**Re: Kingscliff Public School, Kingscliff NSW
OC Structural Certification – Building C Crowd Balustrade**

SITE INSPECTION REPORT

**Re: Kingscliff High School, Kingscliff NSW
OC Structural Certification – Building C Middle (Remaining Works) & Building C West**

SITE INSPECTION REPORT

MP001/0

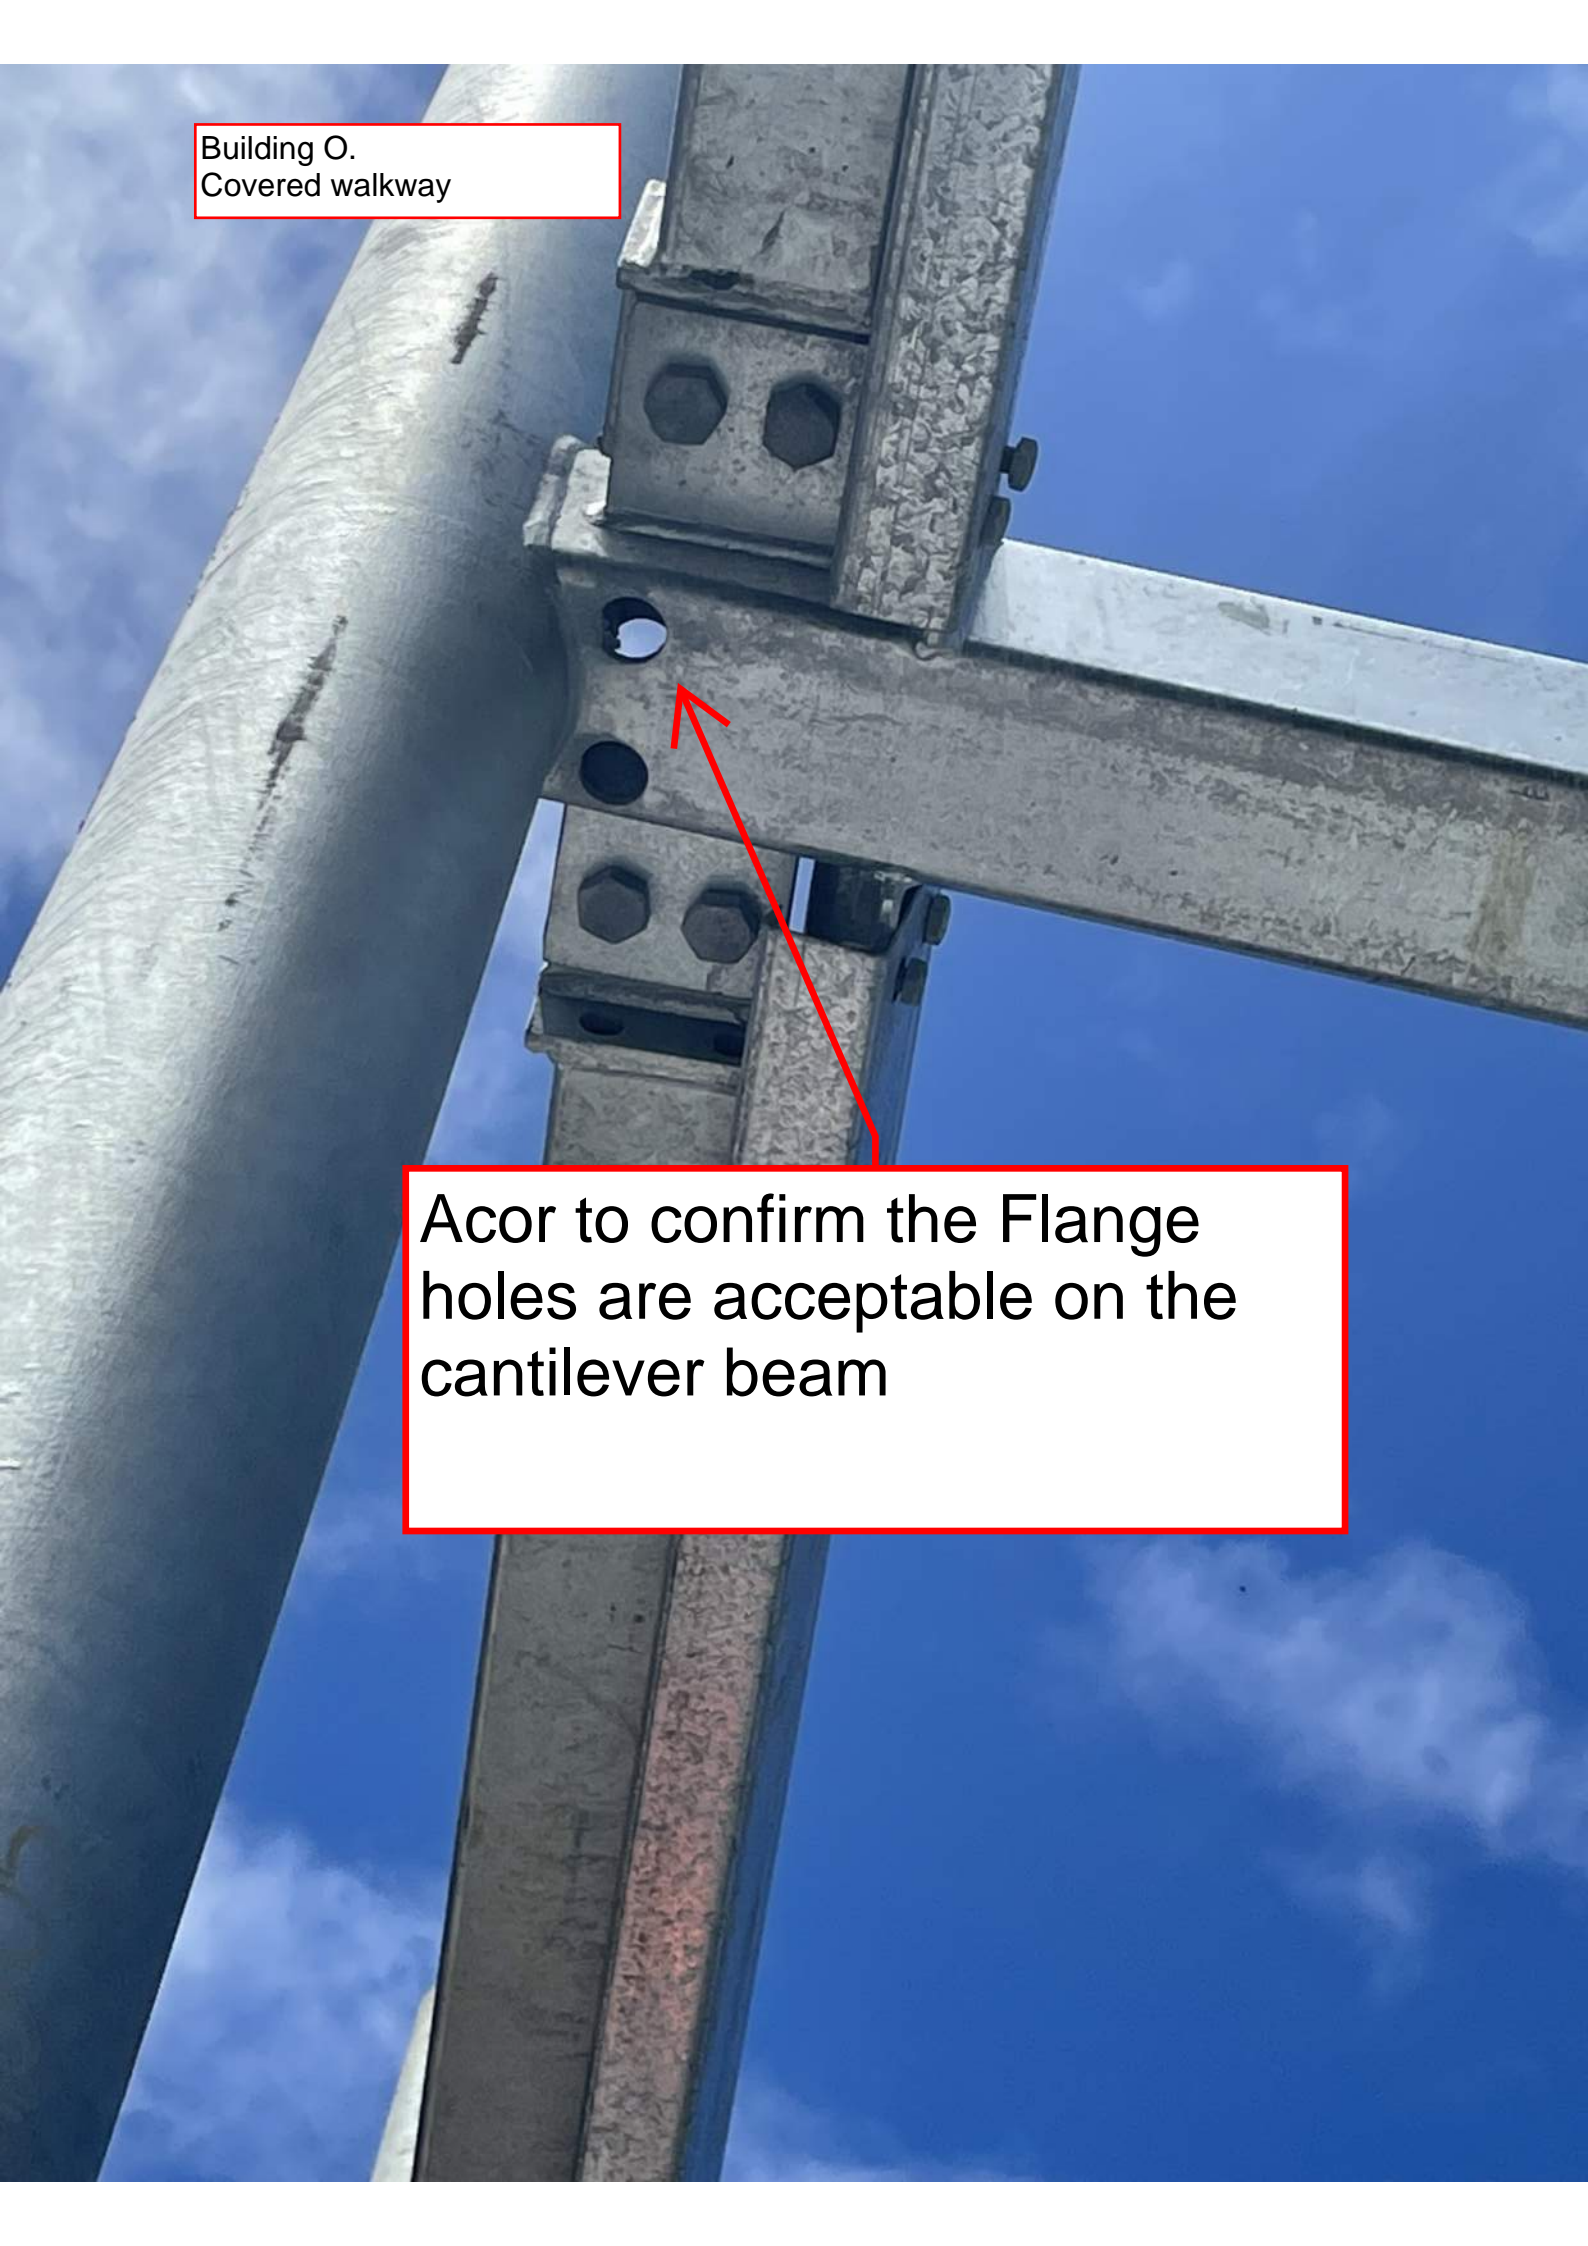
Kitchen steel layout for stiffener plates droppers and transfer beams inspected 17/01/24

Building C.
Additional
balustrade

Building O.
Covered walkway

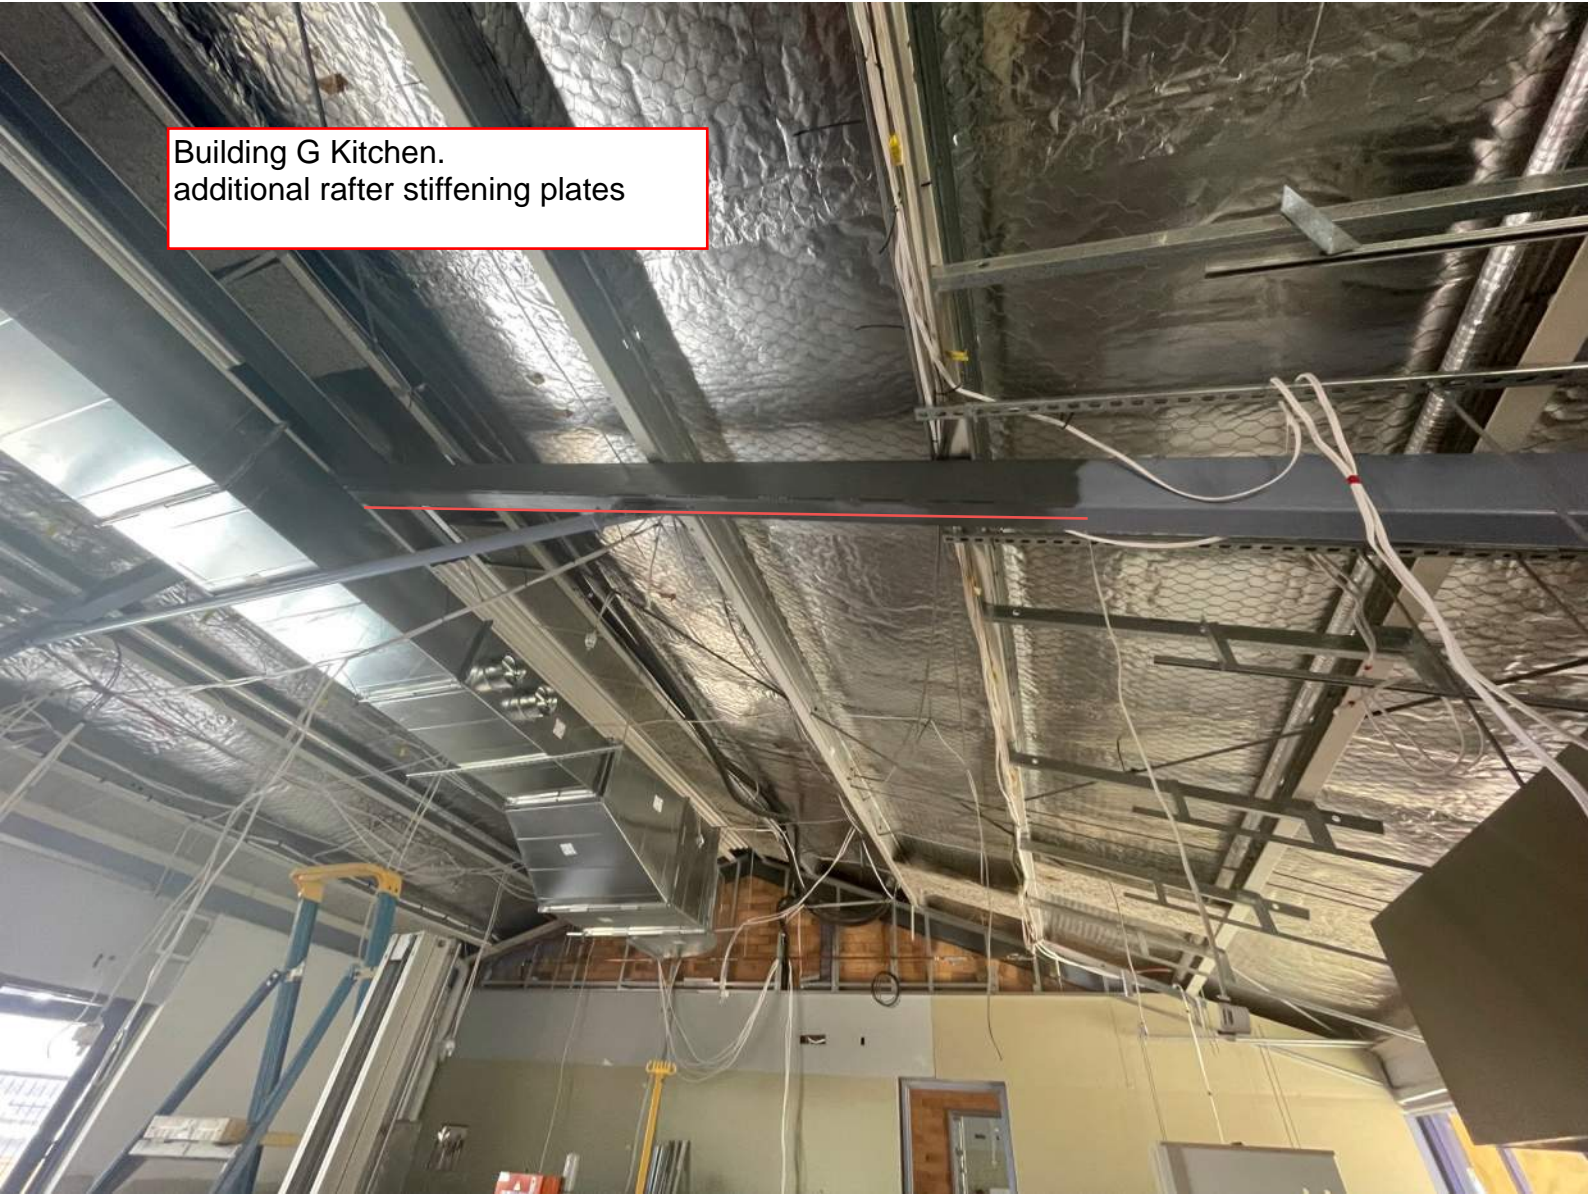
1.
2. Building 0 -
3. - CANTILEVERED OUT RIGGERS SEEM TO HAVE
4. 2 OVERSIZED HOLES - VENTS ?
5. SEE PICTURE - ACOR TO ADVISE IF OK.
6. - ALL REMAINING VISABLE STEEL SATISFACTORY
7. - FINISH TENSIONED STRAP BRACE
8.
9. Building 9 - C, ALL SATISFACTORY.
10.
11.

A close-up photograph of a steel cantilever beam connection. The beam is attached to a vertical column using a flange plate with two hexagonal bolts. A red arrow points to a hole in the flange plate. The background is a clear blue sky with some light clouds.

Acor to confirm the Flange holes are acceptable on the cantilever beam

ROOF FRAMING (MIDDLE) PLAN

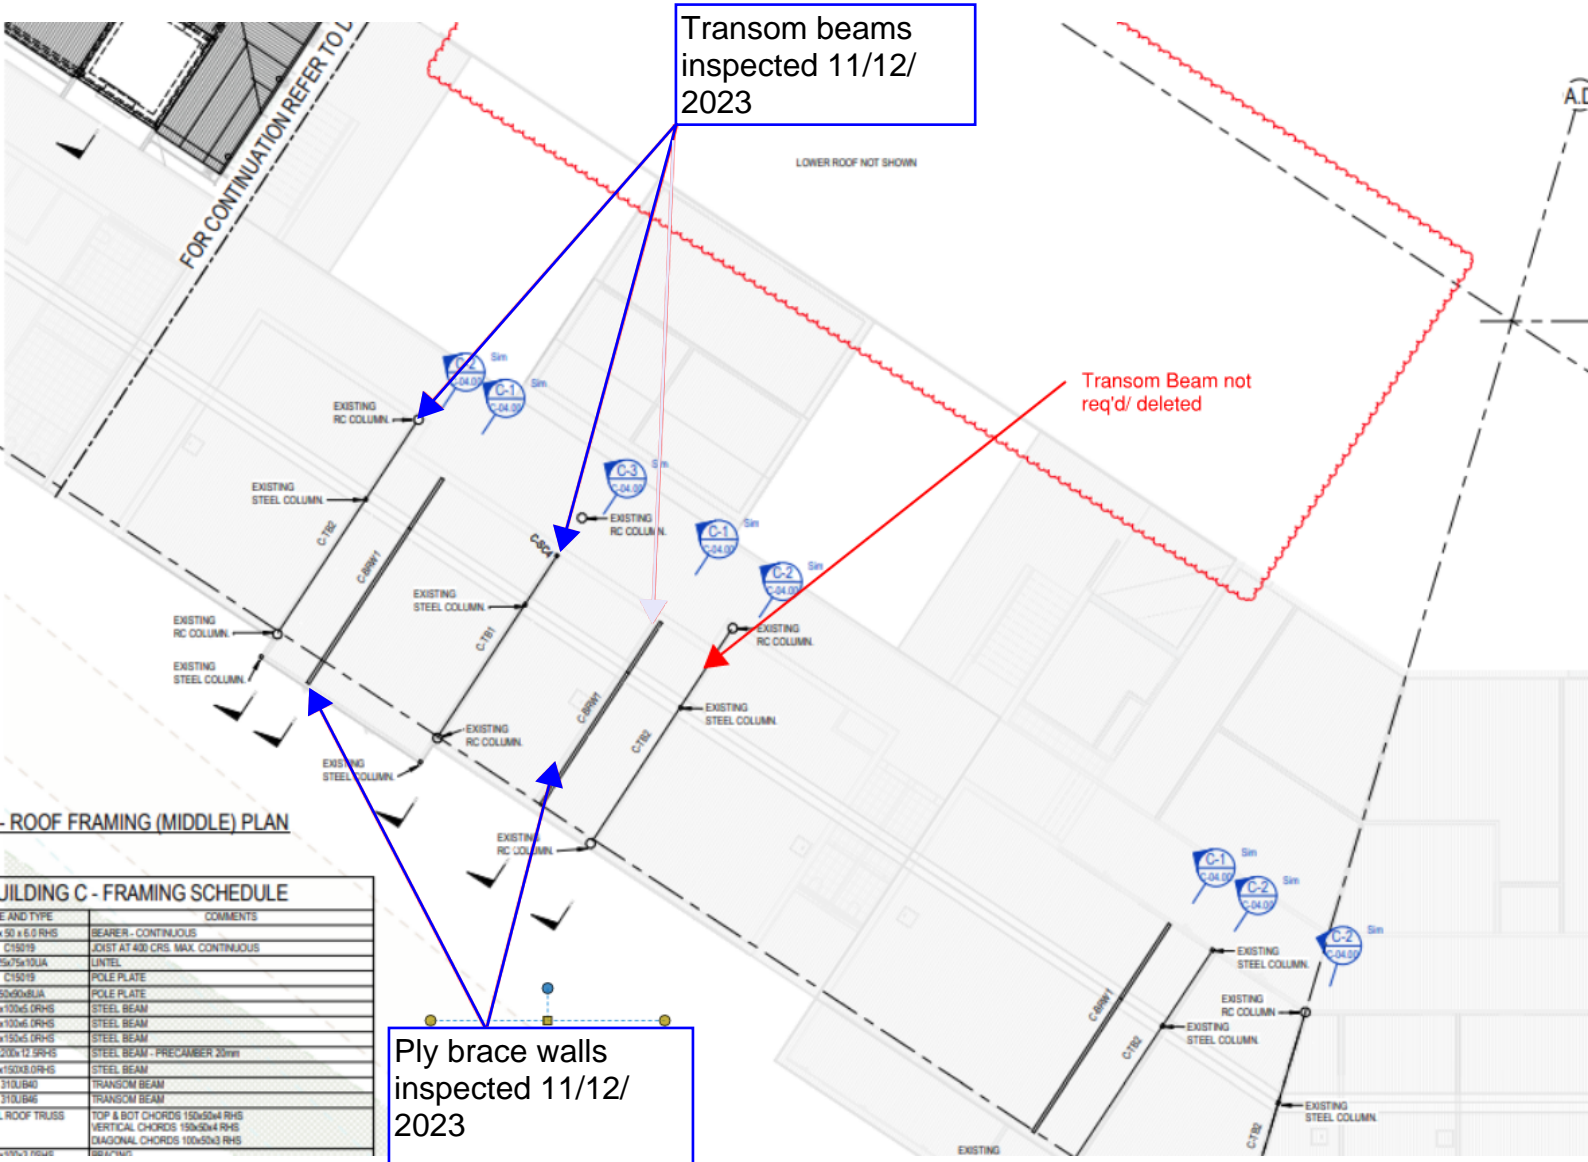
Operable wall head inspected 11/12/2023

Transom beams inspected 11/12/2023

Transom Beam not req'd/ deleted

Ply brace walls inspected 11/12/2023

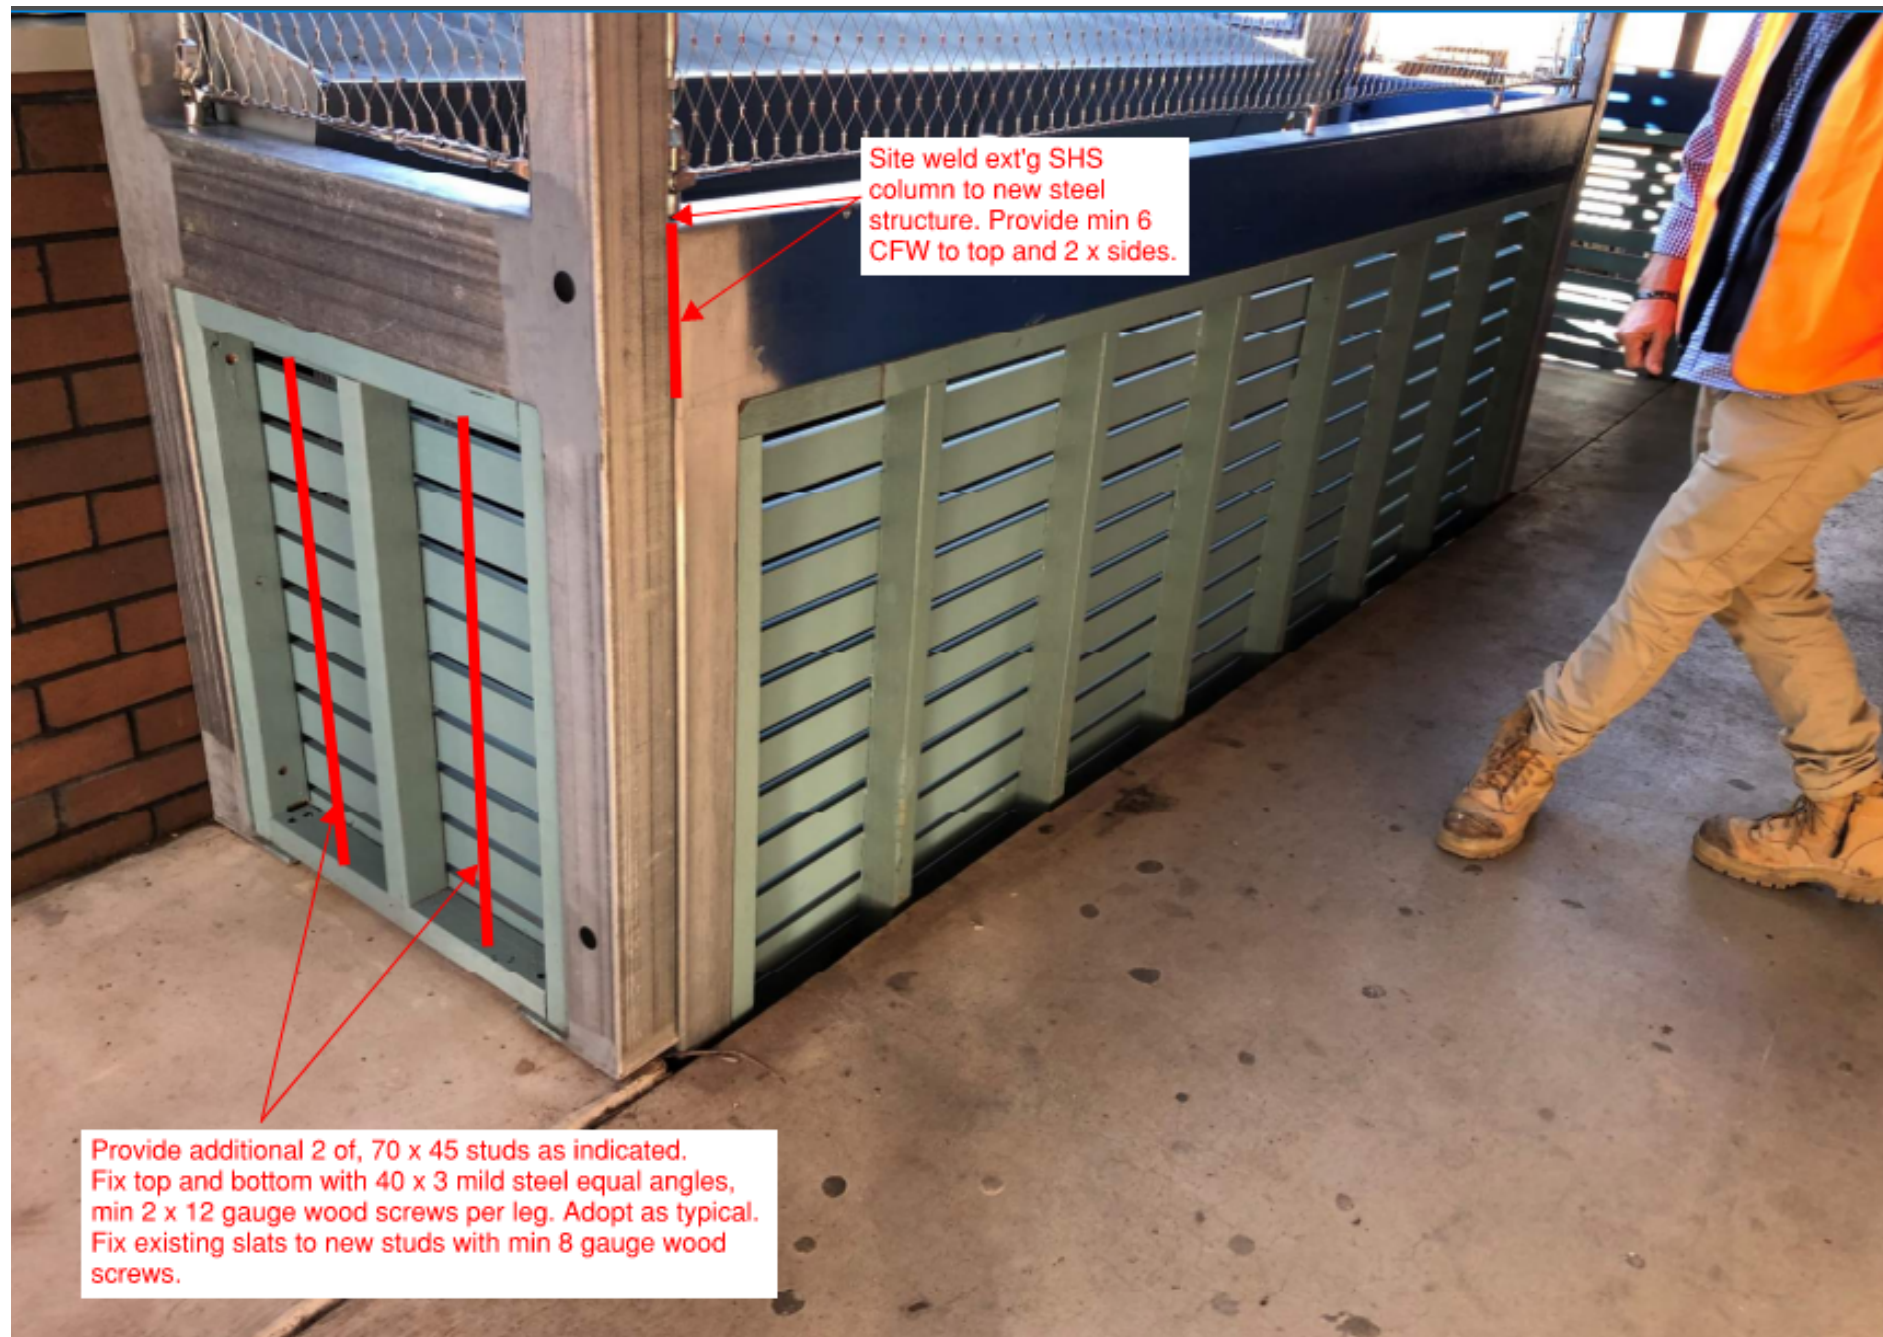
Have you confirmed there is an existing steel column within the wall framing that need to be cut? If there is not, the transom beams will not be required.

The operable wall header detail will be as per the attached detail with 2 steel posts either side of the opening and a 200 PFC header cantilevering both sides. The steel posts need to be laterally restrained by struts that connect to existing roof rafters. The structural bracing ply must be installed on either side of the opening as per our details.

Site weld ext'g SHS column to new steel structure. Provide min 6 CFW to top and 2 x sides.

Provide additional 2 of, 70 x 45 studs as indicated. Fix top and bottom with 40 x 3 mild steel equal angles, min 2 x 12 gauge wood screws per leg. Adopt as typical. Fix existing slats to new studs with min 8 gauge wood screws.

Yes, can confirm Ply Bracing has been installed as per ACOR detail including Operable Door openings.
